DOE/RL-96-73
Revision 3

324 Building Radiochemical Engineering Cells, High-Level Vault, Low-Level Vault, and Associated Area Closure Plan

Date Published
August 2005

Figure 2-11. 324 Building HLV Construction Photograph.

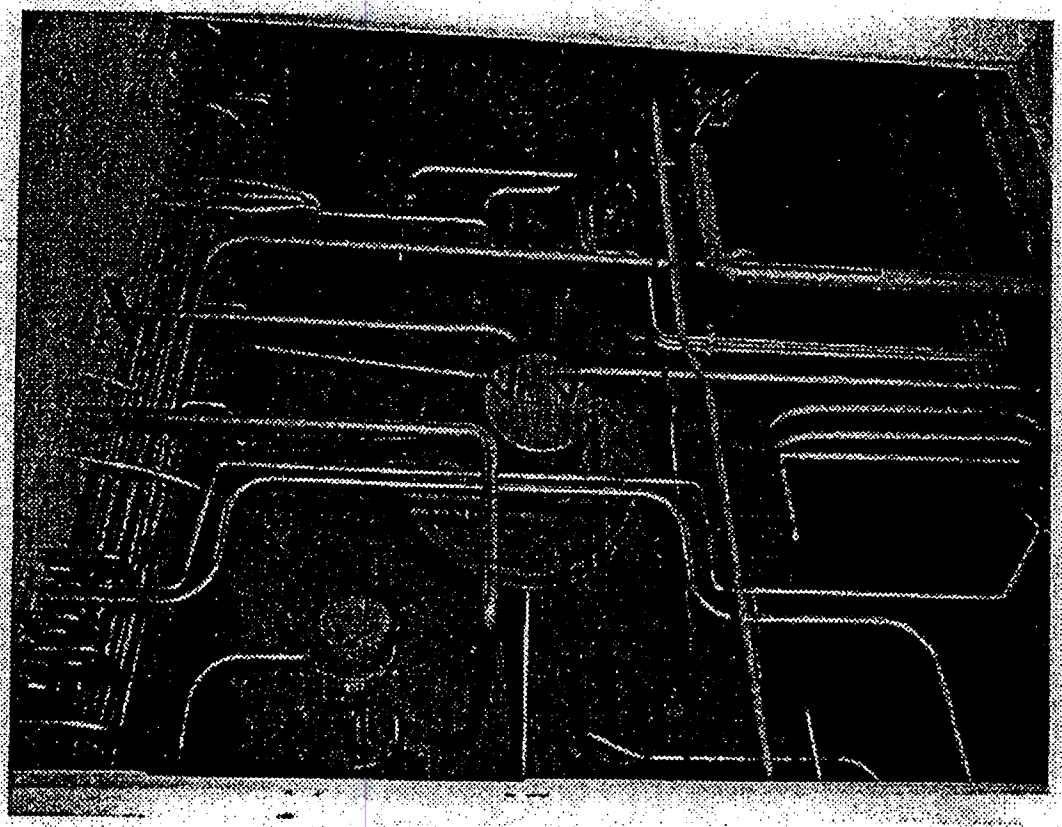
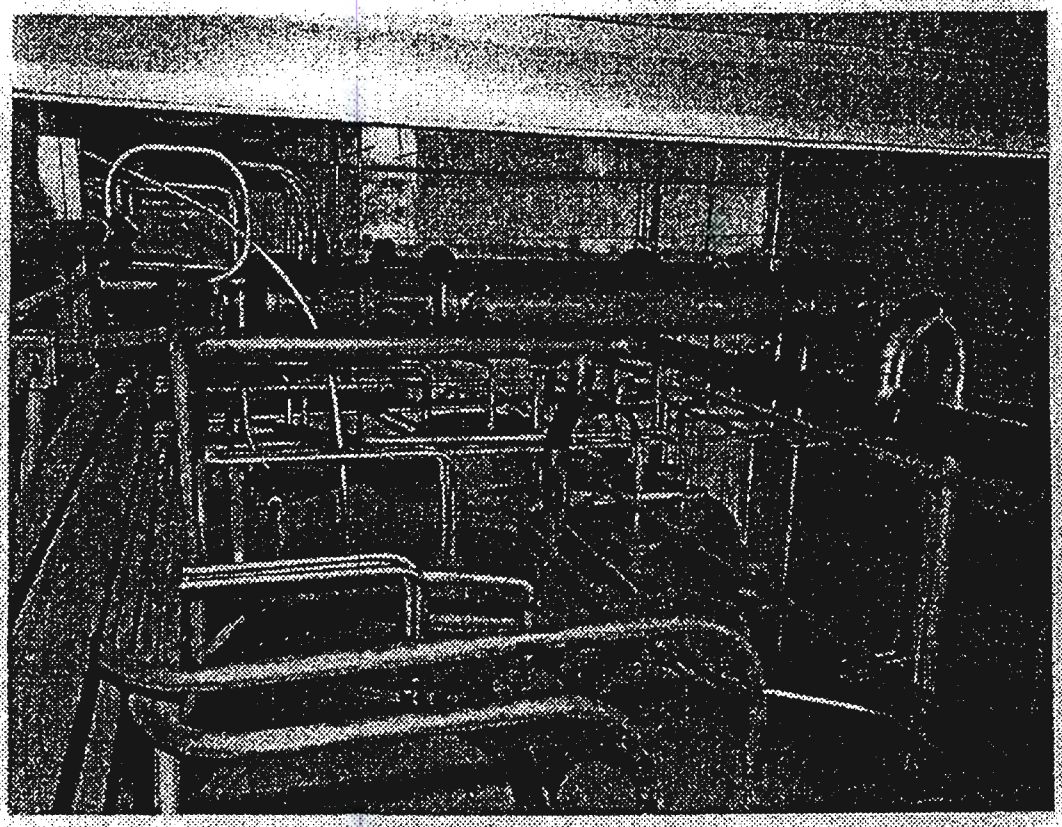
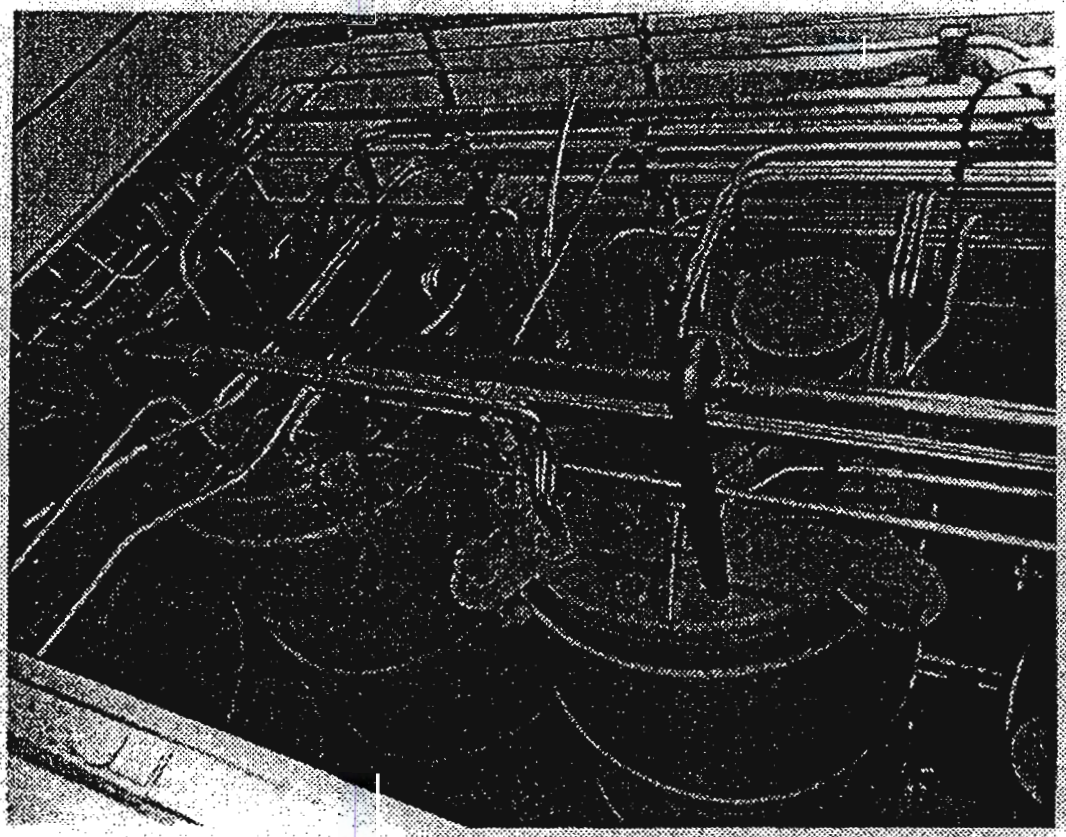
6. Throughout the document detail was removed from figures making them less useful. Due to security reasons it may be appropriate to remove the detail however it is inappropriate to do this without communicating the changes. In addition the quality of the photograph copies are so poor they are virtually useless. For example figures 2-8, 2-11, 2-12, and 2-13. Ecology requests clarification of why detail was removed from the document. Please provide actual photographs and detailed figures rather than copies for official use only. This comment was not made in review of the original plan because the modified figures were not provided in the application for revision.

Comment resolution: Per discussions with Ecology and RL at July/August 2005 workshop meetings, figures have been reviewed as necessary. Photographs have been located and are being inserted to make new figures for figures 2-8, 2-11, 2-12, and 2-13, and will be included in the submittal of Revision 3 of the closure plan to Ecology.
